# HIGHWAY 7 AND HIGHWAY 15 INTERSECTION IMPROVEMENTS TRANSPORTATION ENVIRONMENTAL STUDY REPORT ADDENDUM

**HIGHWAY 7 AND  
HIGHWAY 15  
INTERSECTION  
IMPROVEMENTS  
TRANSPORTATION  
ENVIRONMENTAL  
STUDY REPORT  
GWP 4084-16-00**

DATE: APRIL 27, 2023

**Figure 4-1: Proposed Changes to 2020 Recommended Plan**

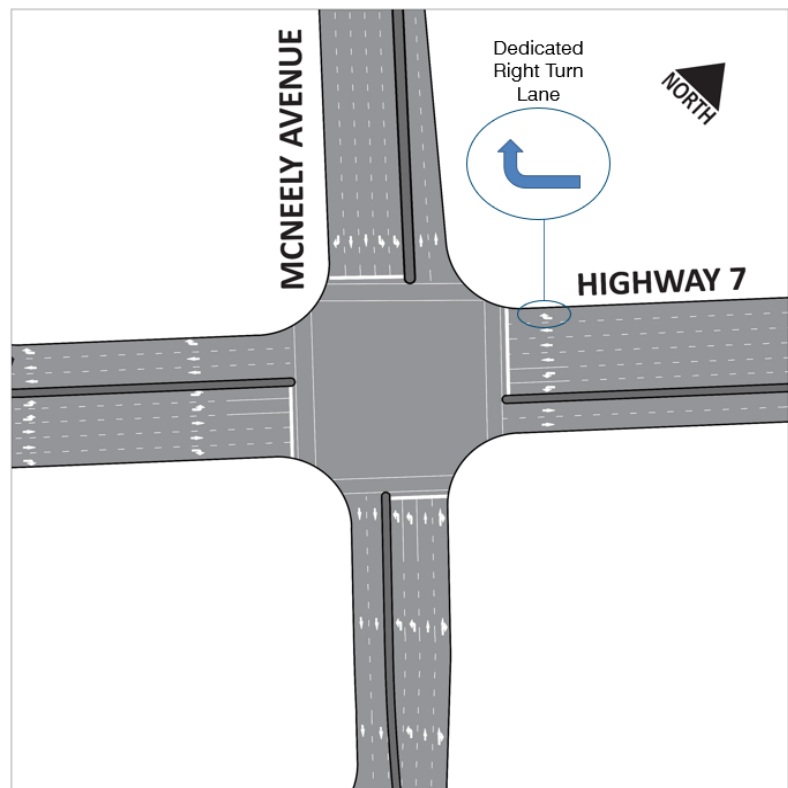
Due to an increase in projected traffic generated by the development north of Highway 7 documented in the updated traffic analysis, it is recommended that the dedicated right-turn lane on Highway 7 be implemented as part of the planned Highway 7 widening work to reduce delay and queuing at the Highway 7 westbound approach at McNeely Avenue as identified in **Figure 4-1**.

# PROPOSED CHANGES TO 2020 RECOMMENDED PLAN

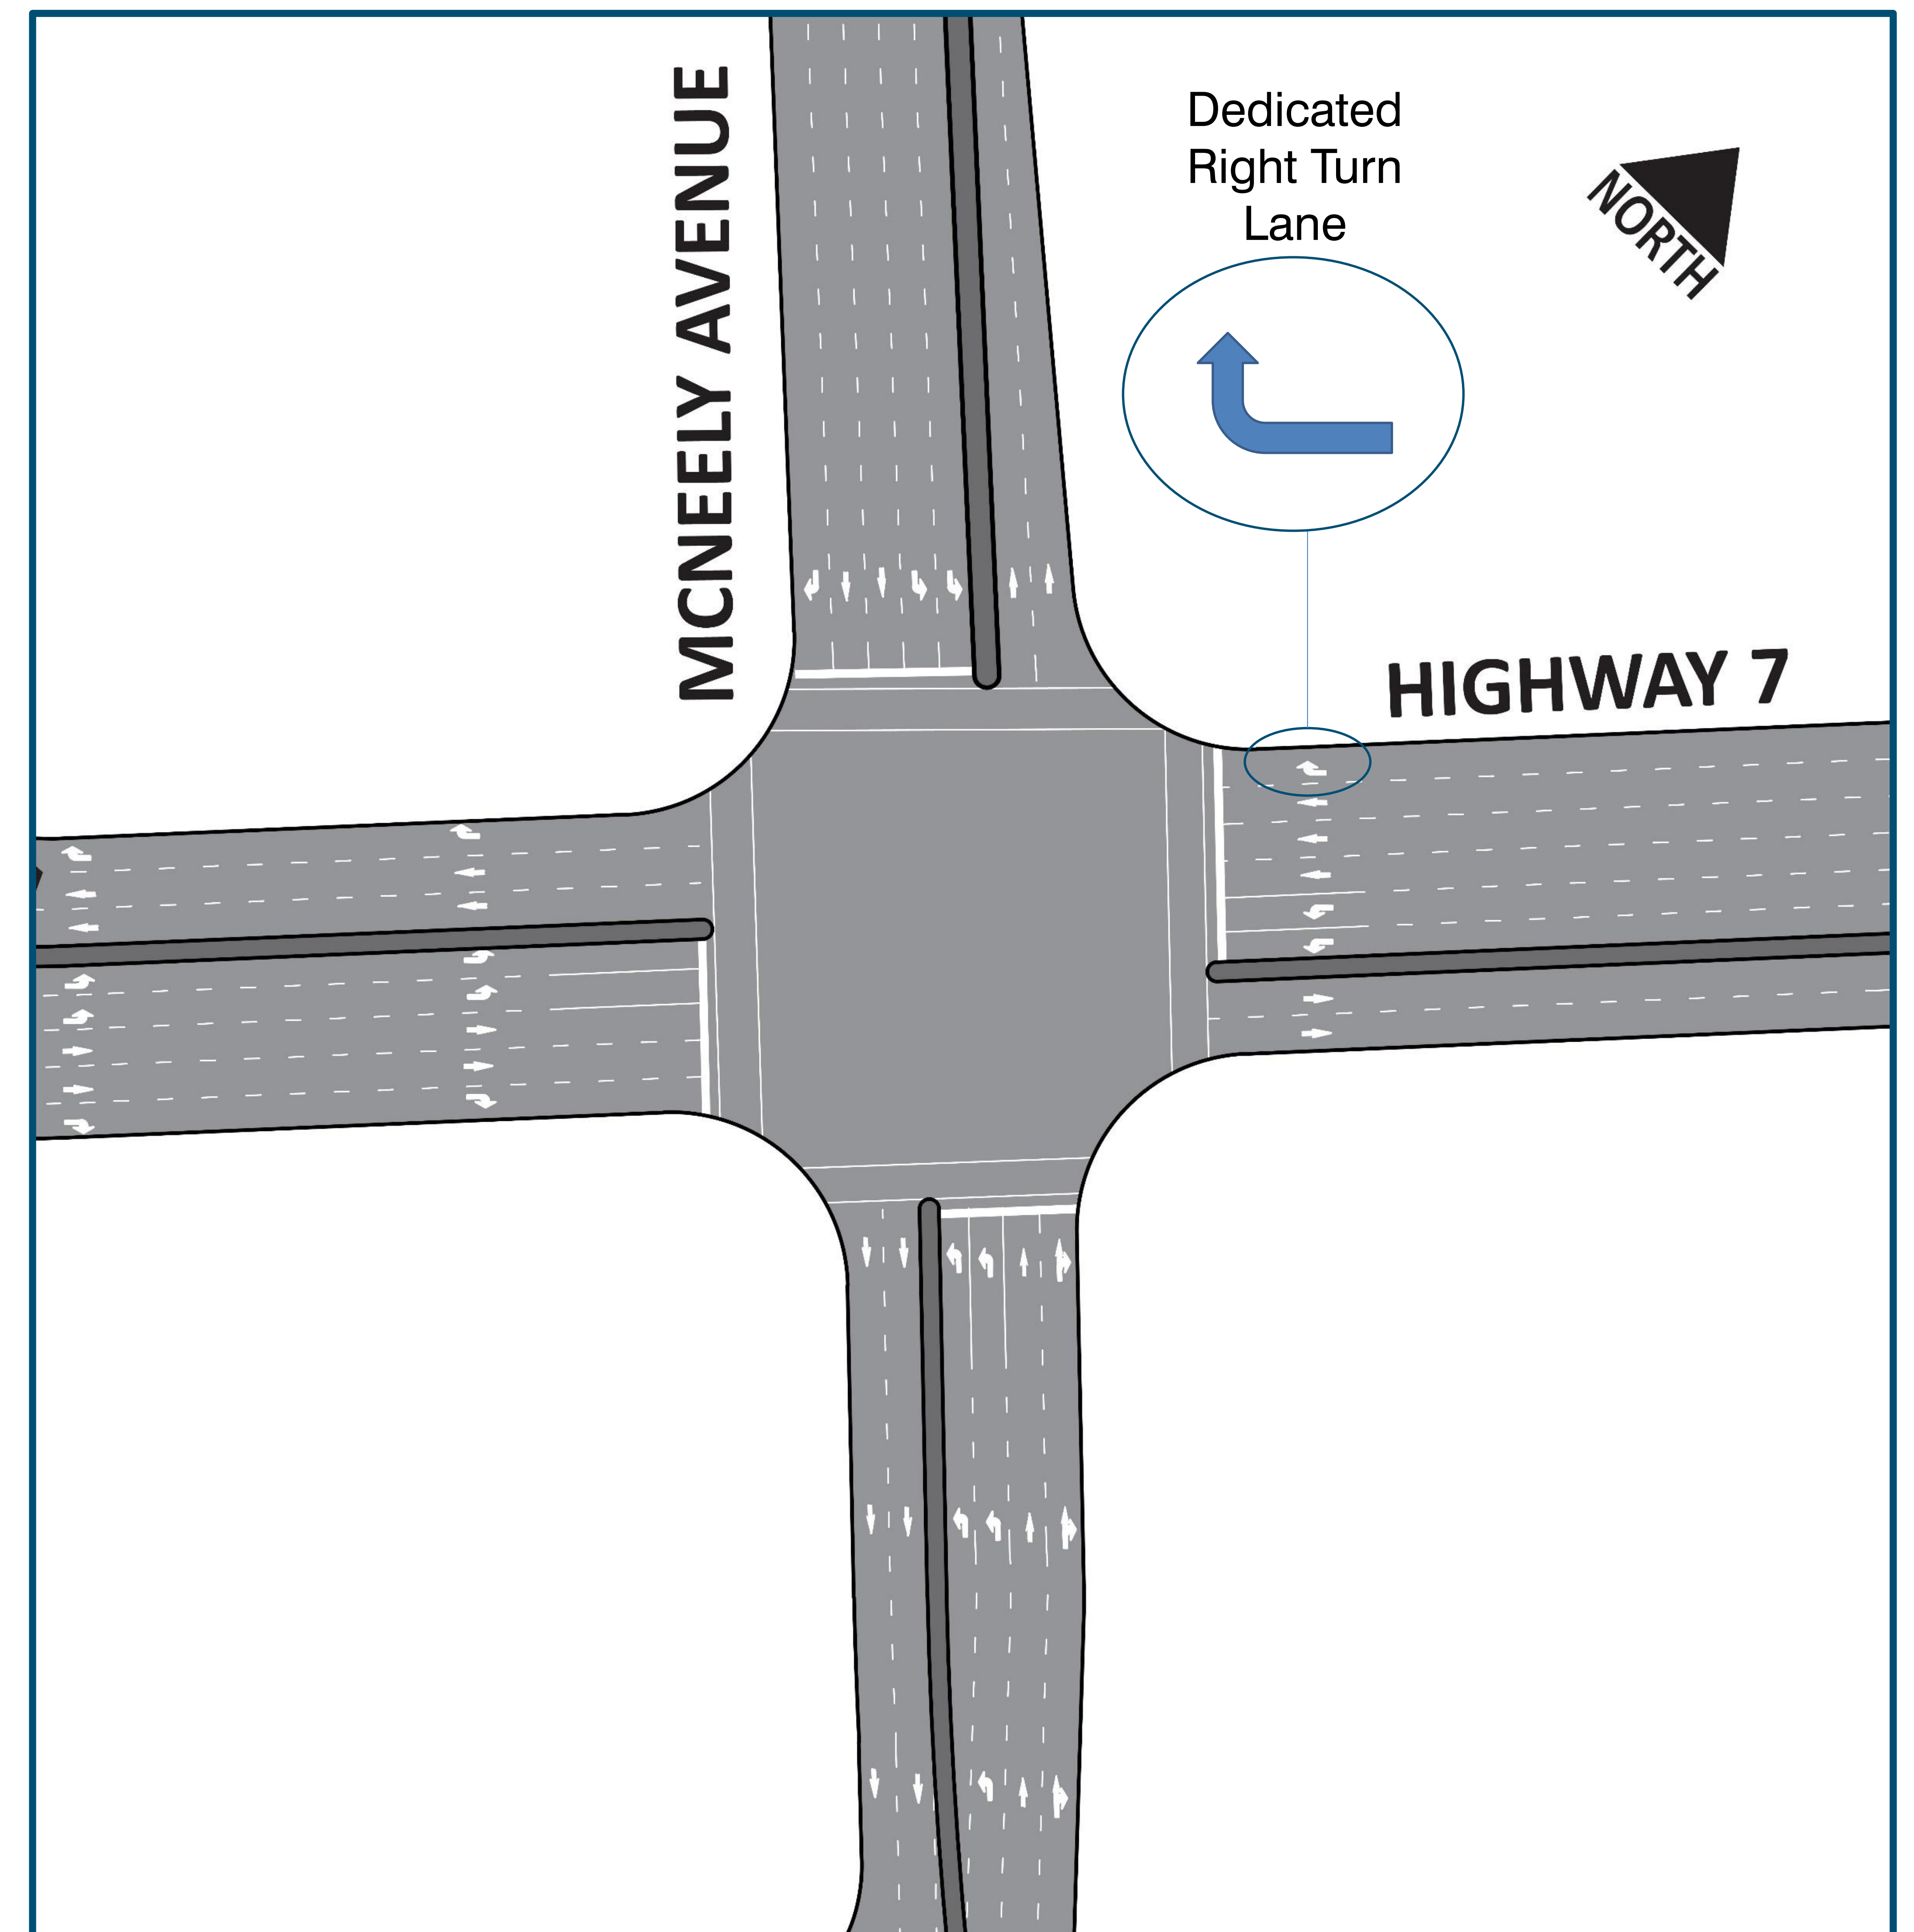
## Section 6.1.4.2 of the 2020 TESR states:

- The Highway 7 westbound direction at the McNeely Avenue intersection is recommended to operate with three through lanes plus a dedicated right turn lane for the long-term condition (i.e., 2040 and beyond). However, to reduce the crossing distance for pedestrians, the **westbound approach is recommended to have two through lanes plus a shared through / right lane** during interim improvements.
- **MTO is recommended to periodically monitor traffic operations at the westbound approach and if required, implement the dedicated right turn lane** to reduce delay and queuing for the westbound approach.

Preferred Alignment of the EW Public Roadway

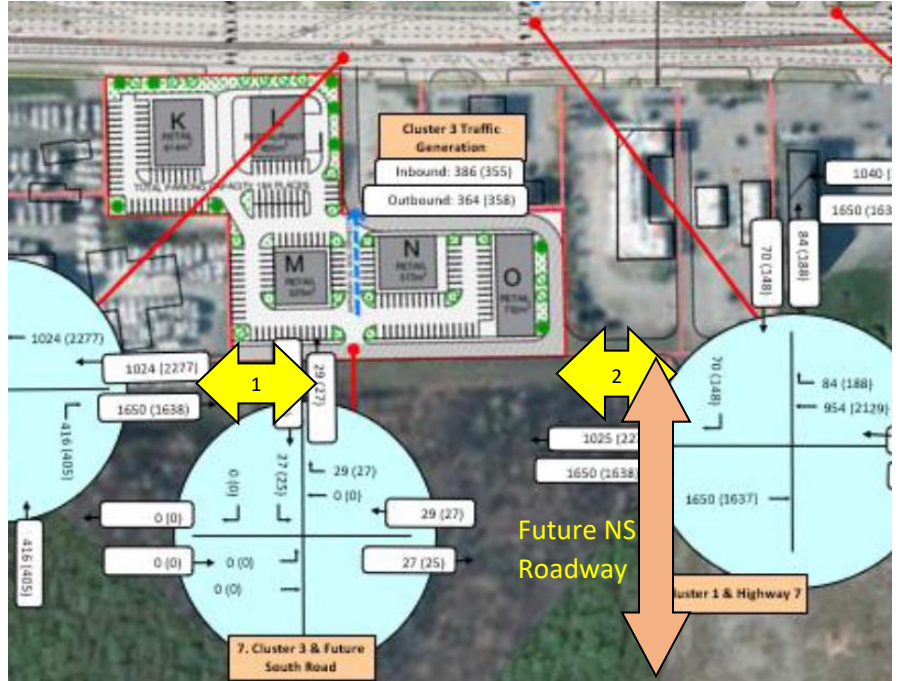
2. **Alignment of EW Public Road:** The alignment as shown in MTO's Alignment 3A illustrated in the Public Information Centre material held November 22<sup>nd</sup> 2022 is inconsistent with Fotenn's plans of development that were submitted for consideration to both MTO and the municipality. The site plan preferred by Maniplot illustrates a roadway which maximized the development of Maniplot's Lands. The yellow cross hair symbol indicates where MTO would place the intersection. The alignment of the EW roadway is unacceptable from Maniplot's standpoint and diminishes the development potential of the Maniplot's Lands.

Note the preferred alignment of the EW roadway is to the north of that illustrated in MTO's concept would extend the two Frank Town Road NB Thru lanes to a point north of Findlay Avenue and begin the taper to a single lane north of the intersection. The NB-RT lane into Maniplot's development would be in addition to the thru lane.

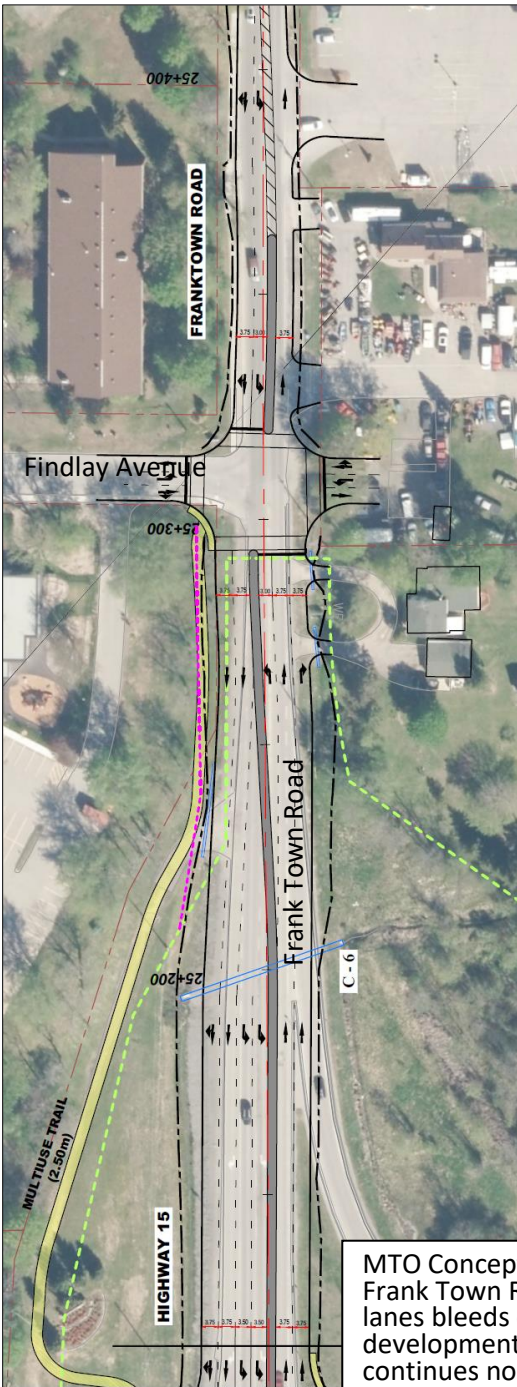
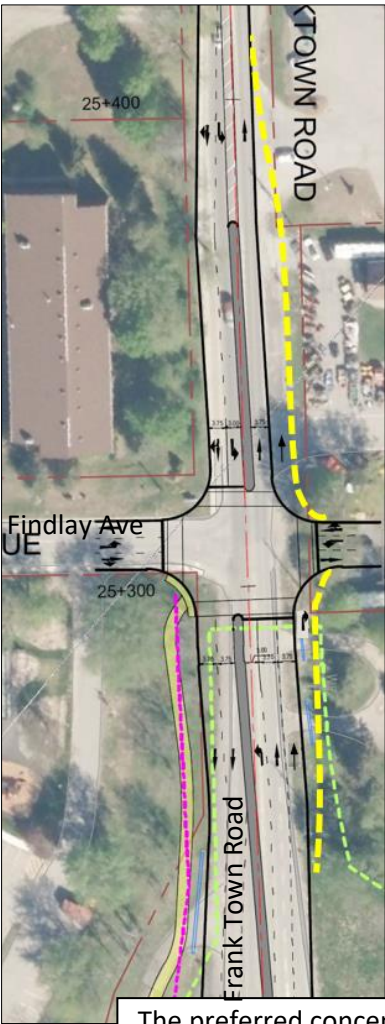
4. **Frank Town Road / Findlay Intersection:** The images below illustrate the MTO proposed Findlay Avenue/Frank Town Road intersection configuration on the left and the modification necessary to accommodate Maniplex's development on the right. We concur with MTO that the intersection should be upgraded to provide a SB left turn lane and a NB right turn lane onto the proposed new public roadway. However, our analysis concludes that failure levels of service result without having the two NB approach lanes carry through to the north side of the intersection as illustrated on the exhibit on the right side. The MTO design chose to terminate the outer northbound through lane (which extended 430m to the south at the Highway 7 intersection) by simply converting it to a right turn only lane in advance of the intersection. This would require motorists to shift lanes to proceed north. The traffic analysis concluded that Franktown Road should be widened to extend the planned 2<sup>nd</sup> NB through lane through the intersection where it would then merge with the downstream portion of the intersection, as shown in the image on the right. Property does not seem to be an issue as the required lands appear to be within the roadway right-of-way.

MTO Concept indicates two NB lanes on Frank Town Road. The outer of the two lanes bleeds off onto Maniplex's development and only a single lane continues northward.

The preferred concept would extend the two Frank Town Road NB Thru lanes to a point north of Findlay Avenue and begin the taper to a single lane north of the intersection. The NB-RT lane into Maniplex's development would be in addition to the thru lane.
